Schematic Name: SCHEMATIC1			
Page Title: PAGE1		Engineer: Luke Coletti	
Project Name: Chemical Sensors	Group Name: ChemicalSensors		Designer: Jose Rosal
System: ISUS V2	Subsystem: <Subsystem>		Last Updated By: jrosal
Drawing Number: 100221520	Release: A	Version: 4	Status: Active
Page Modify Date: Monday, September 18, 2023	Check In Date: 9/18/2023 3:36:40 PM		Size: C
		Sheet 1	of 1

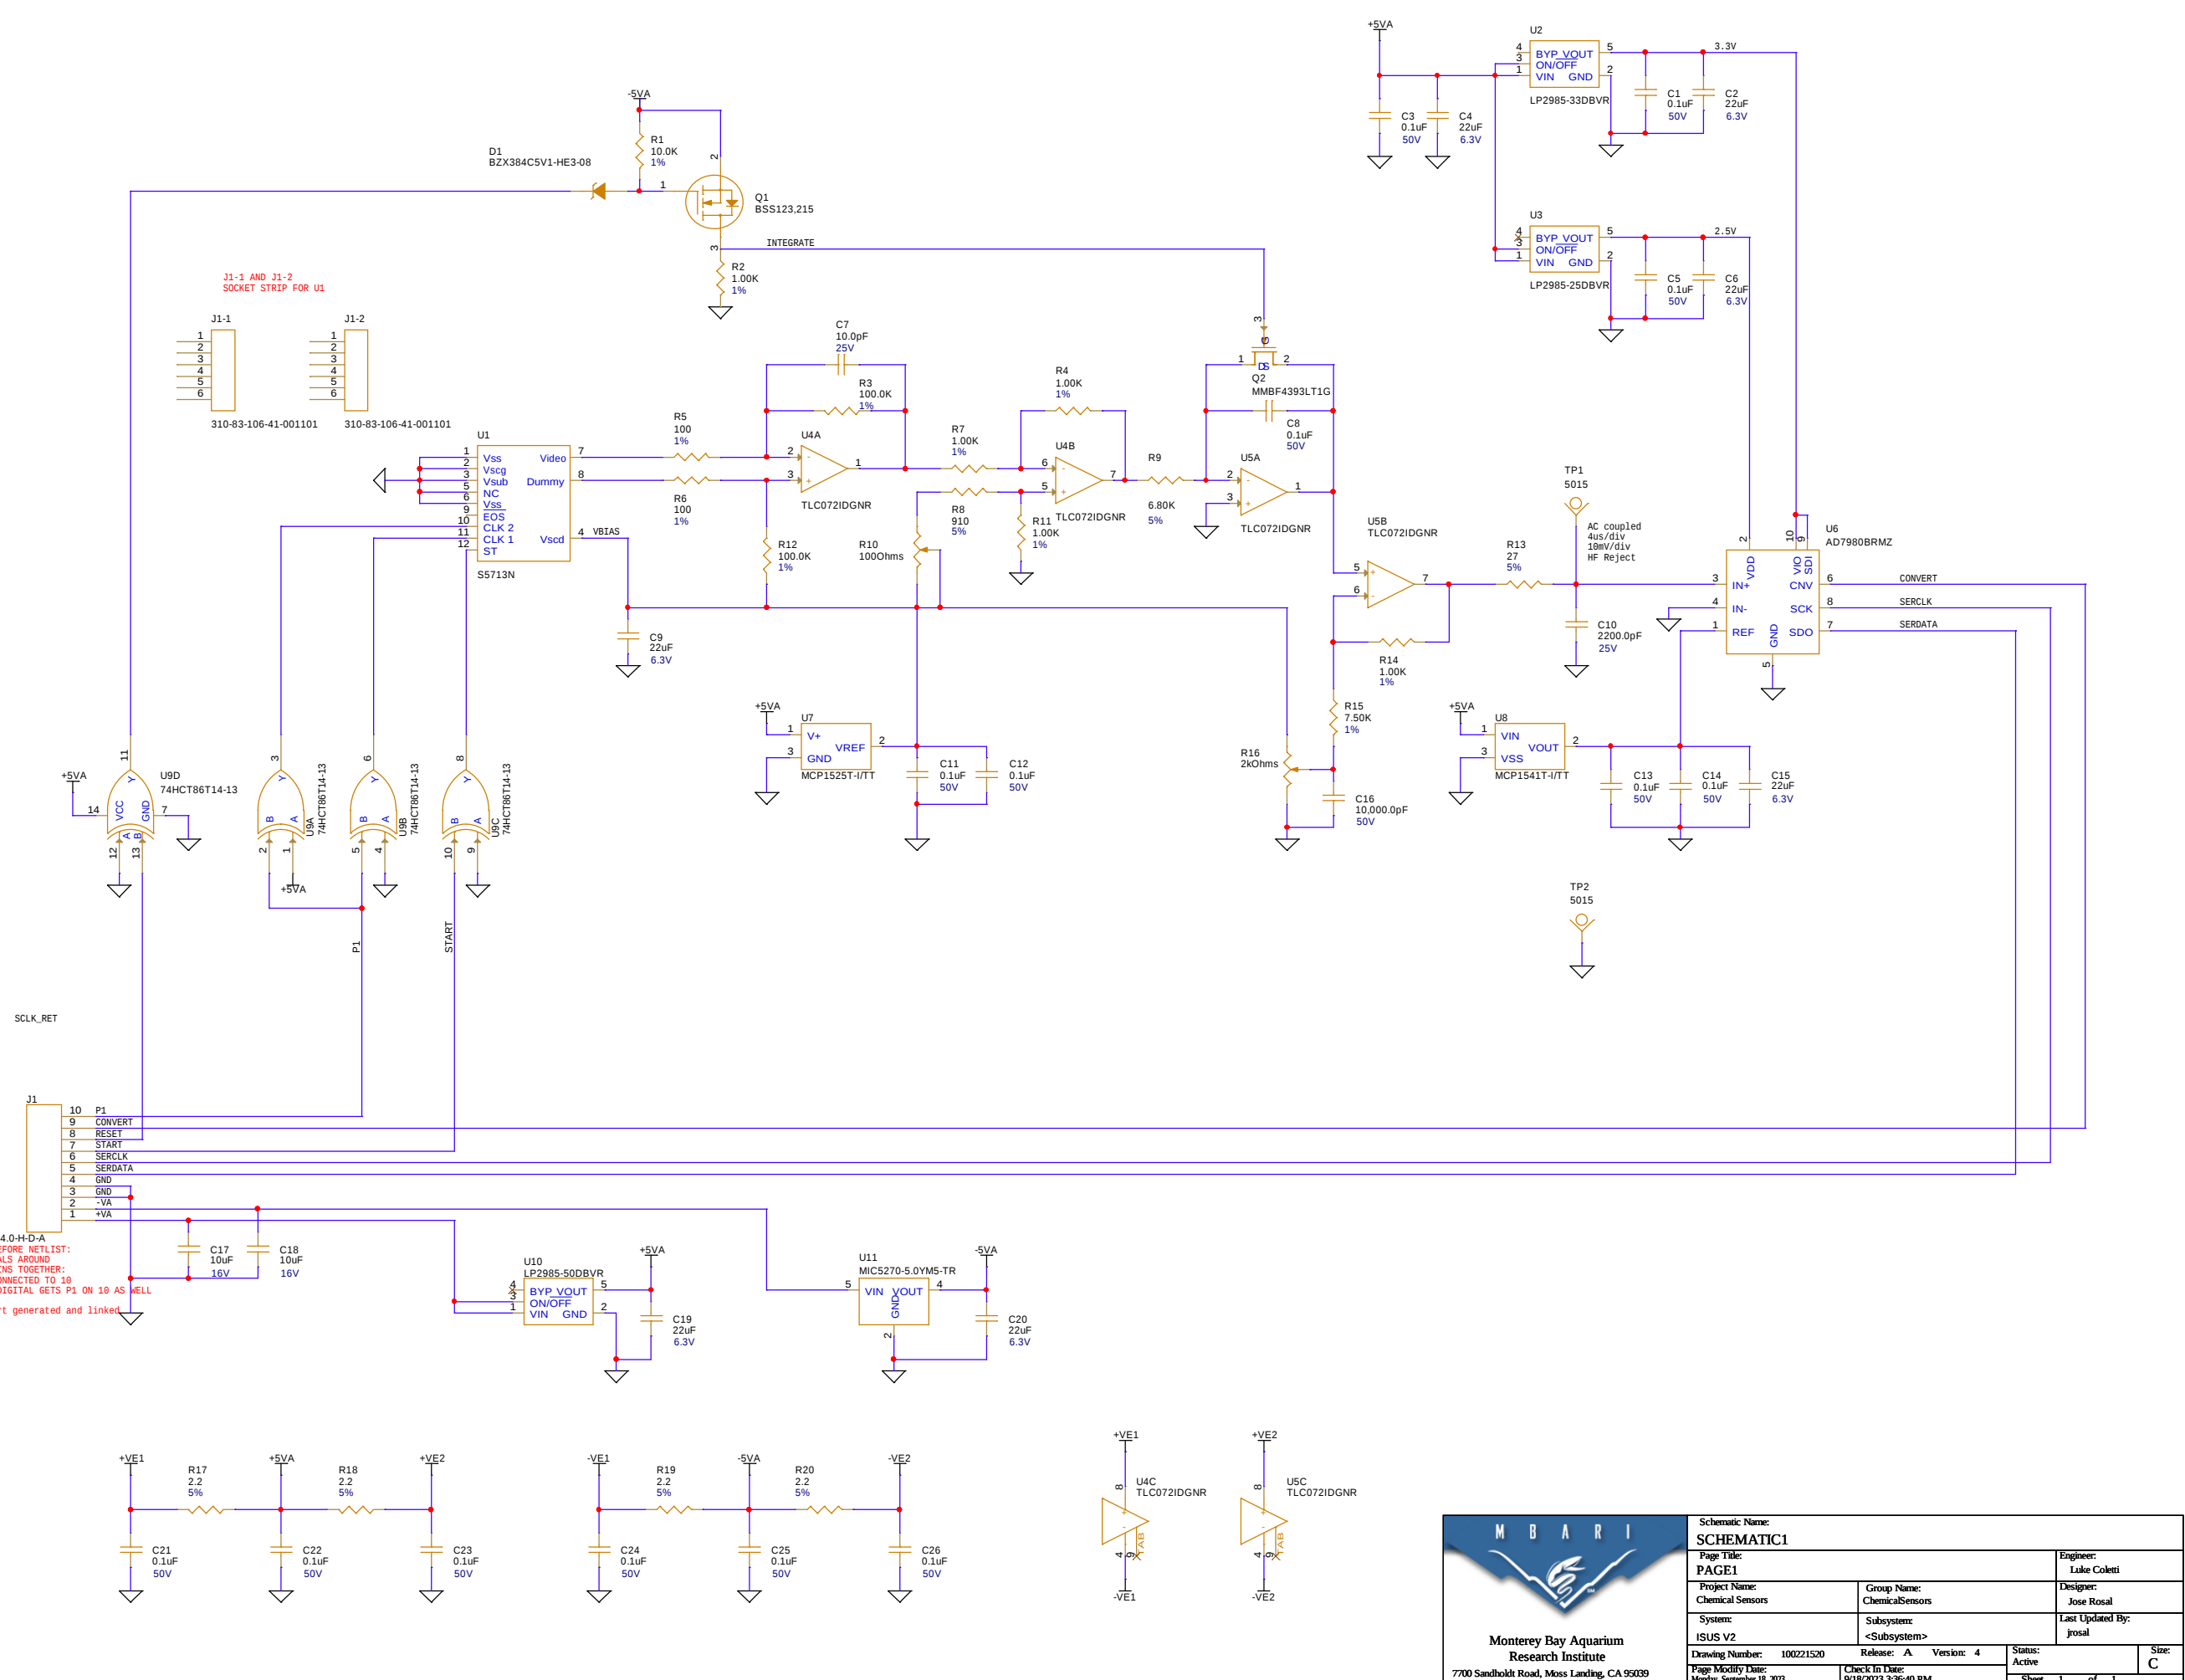
TEM-105-02-04.0-H-D-A
LINK THIS PART BEFORE NETLIST:
I CAN MOVED SIGNALS AROUND
KEEP ALL 3 PMR PINS TOGETHER:
P1 NEEDS TO BE CONNECTED TO 10
ON THIS BOARD. DIGITAL GETS P1 ON 10 AS WELL
-091823 _ CIP part generated and linked
